2nd Further Information

**Proposed Temporary Shop and Services (Vehicle Showroom) for a Period of 3 Years in
“Other Specified Uses” annotated “Rural Use” Zone, Lots 564, 565 (Part)
and 618 S.C (Part) in D.D. 106, Kam Sheung Road, Yuen Long, New Territories**

(S.16 Planning Application No. A/YL-KTS/983)

Responses-to-Comments

Aerial Photo 1

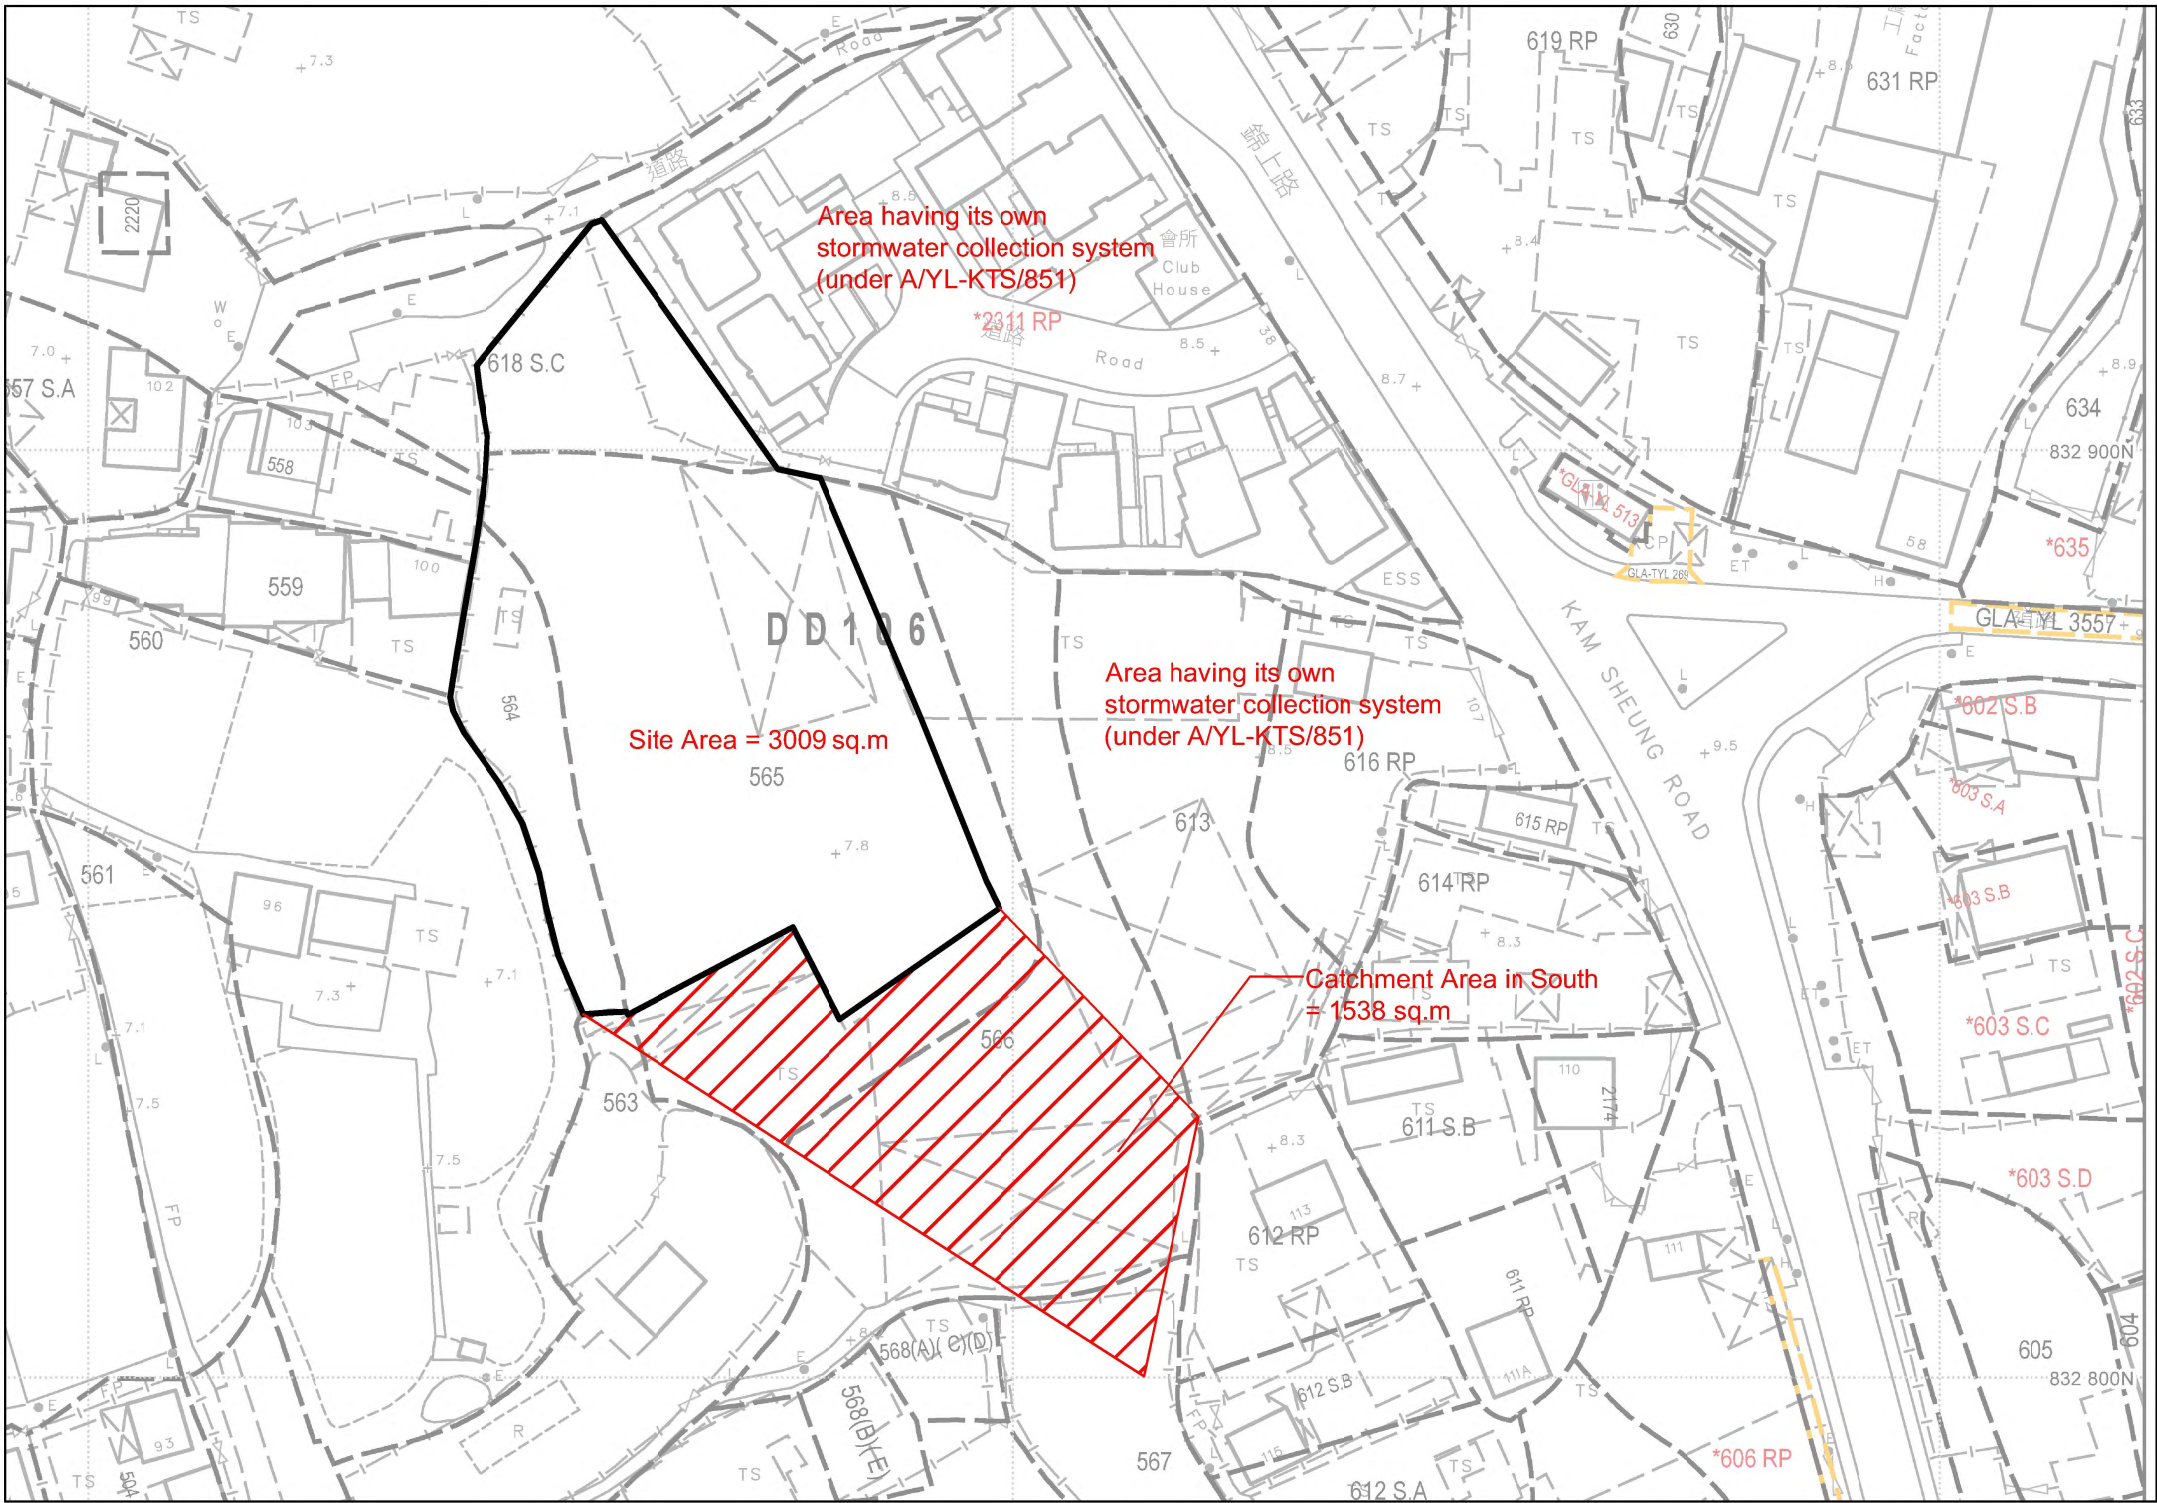
Departmental Comments		Applicant’s Responses
1. Comments of Chief Engineer/Mainland North, Drainage Services Department (CE/MN, DSD)		
(a)	The proposed 450mm u-channel connecting from the catchpit with sand trap (CP2) to the existing 525mm u-channel and the proposed catchpit (CP10) are outside the application site and the existing 525mm u-channel seems located with other private lots(s). The applicant should consult DLO/YL and seek consent from the relevant owner for any drainage work to be carried outside his lot boundary before commencement of the drainage works.	A revised drainage proposal is provided (Annex I). The location of the existing drainage facility and proposed drainage system is revised.

Aerial Photo 1: Full Discharge path

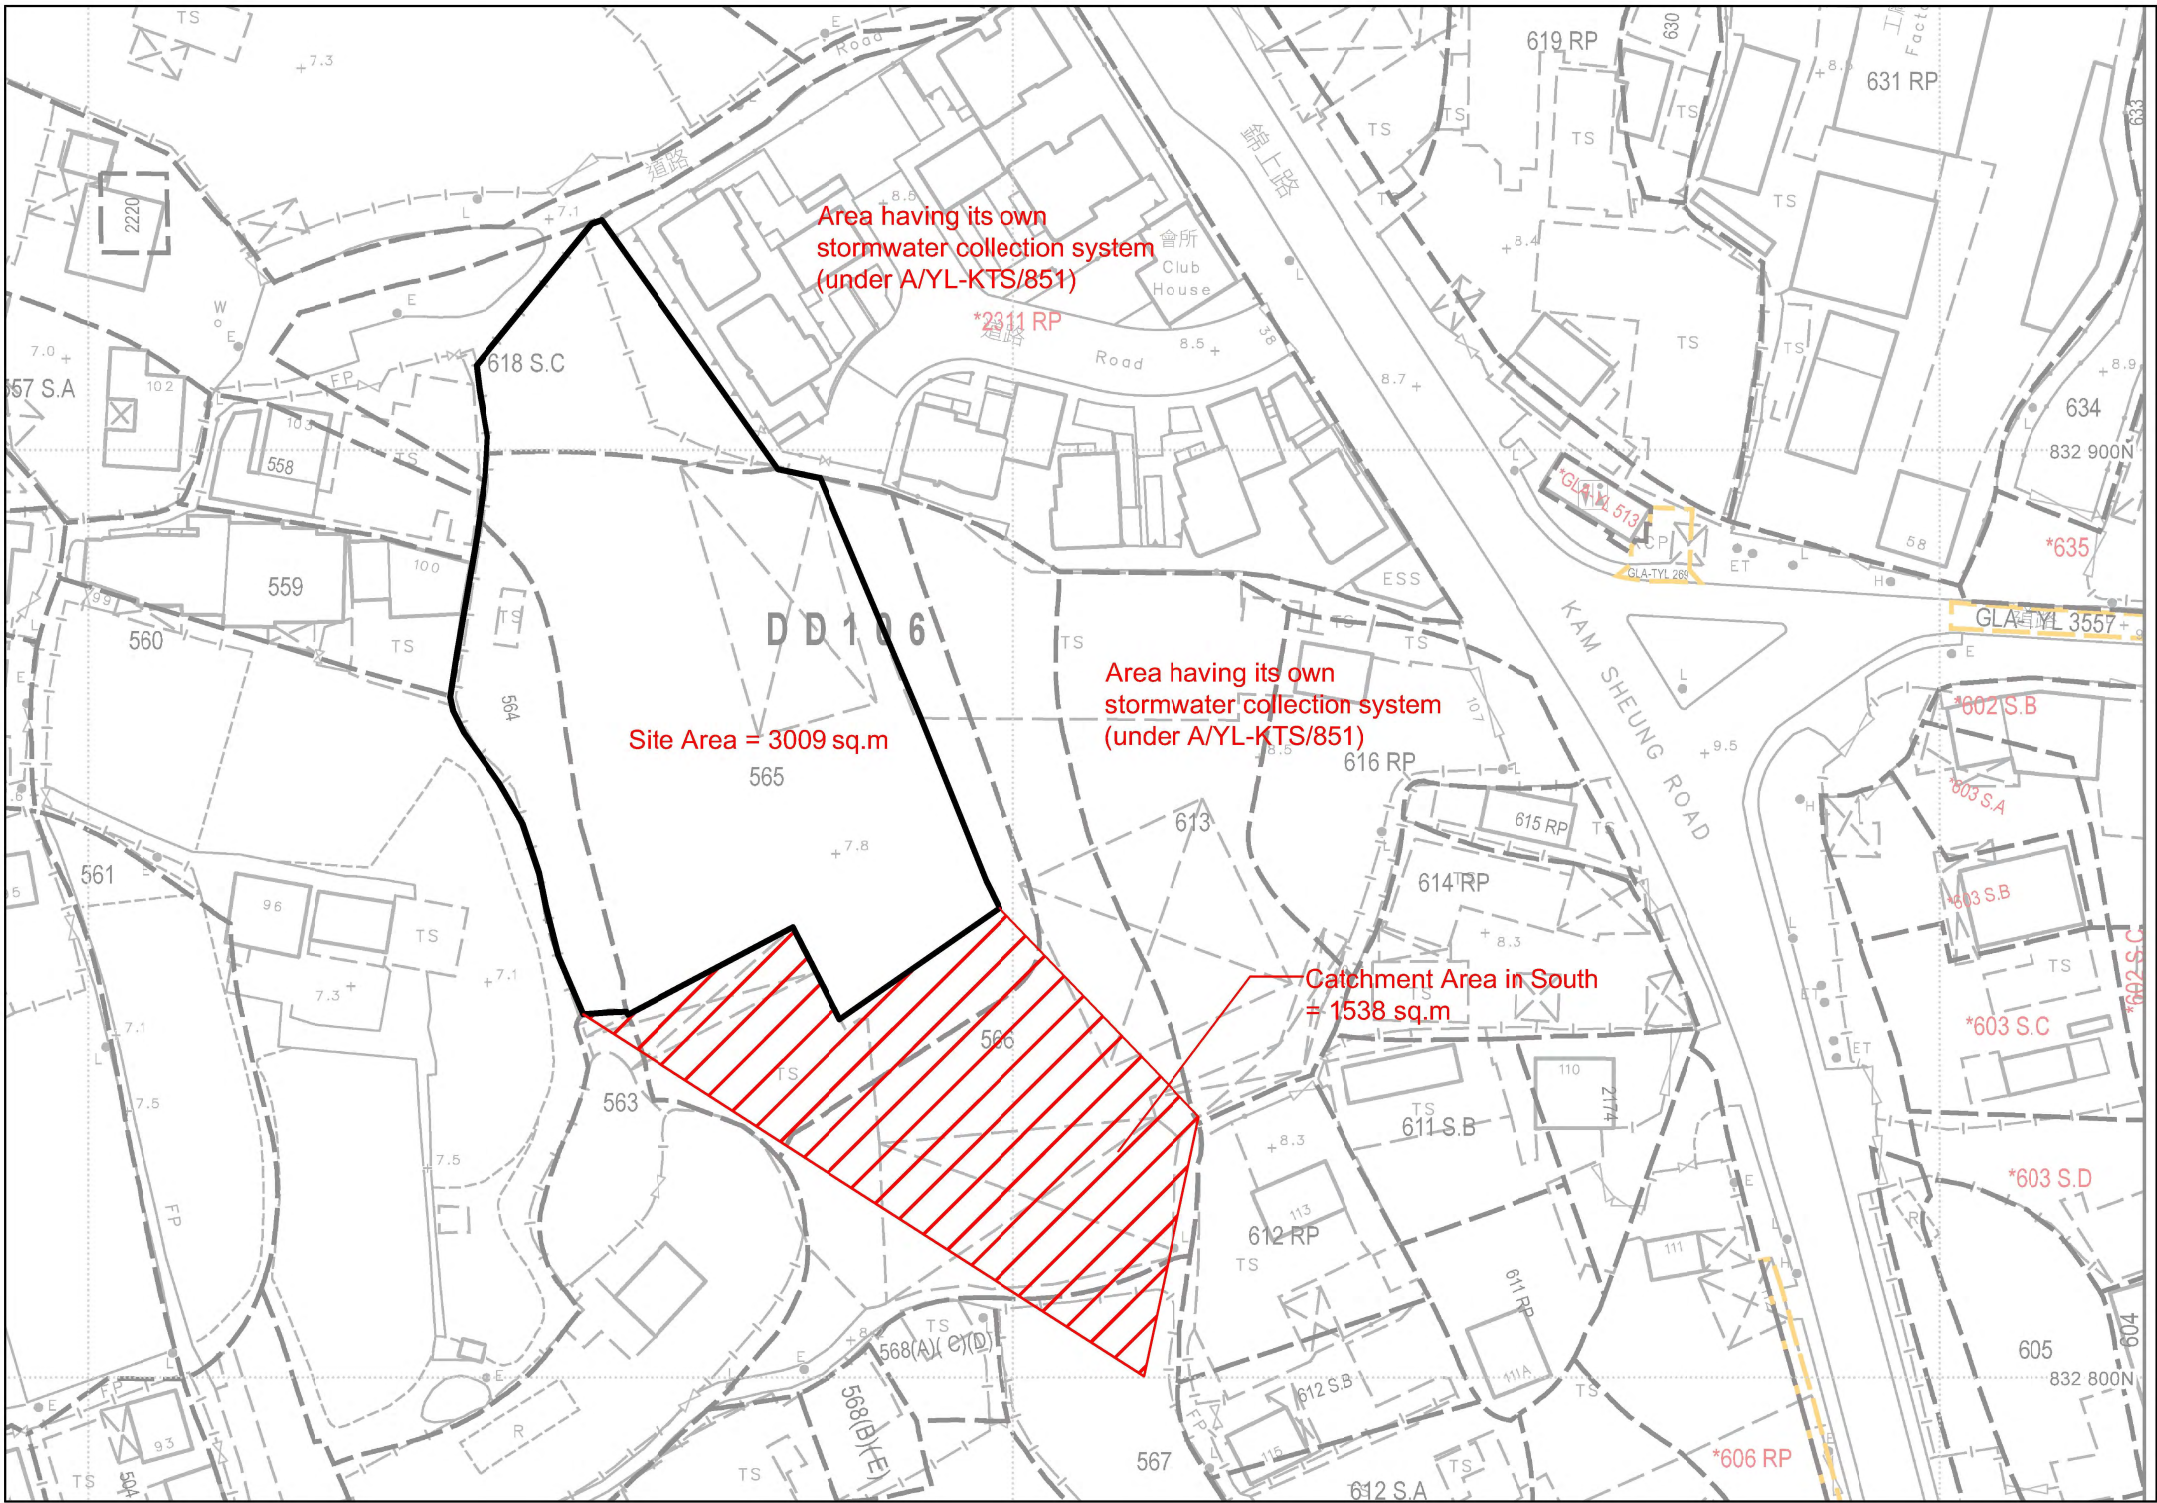
(b)	Please provide more photos at different locations along the full alignment of the discharge path to demonstrate the presence and existing condition along the existing 525mm u-channel for review.	Photos are updated for your reference.

(d)	Discrepancy between the ground levels showed in the plan and sections are found. Please clarify.	It is clarified accordingly.
(e)	Please provide the CL and IL of the proposed discharged point near lot no. 544 RP. Please provide photos showing the existing 525 UC and the 600mm diameter drainpipe at the above discharge point.	Photos are provided for showing existing drainage facility while some area is inaccessible. Most of photos are taken by Aerial Photography.

(f)	The photo numbers and the viewpoints showed in plan are mismatched.	It is revised accordingly.
(g)	The condition of the existing discharge point shown in photos view 1a and 1b are poor. Please rectify.	Existing discharge point is cleaned, and photos are retaken.
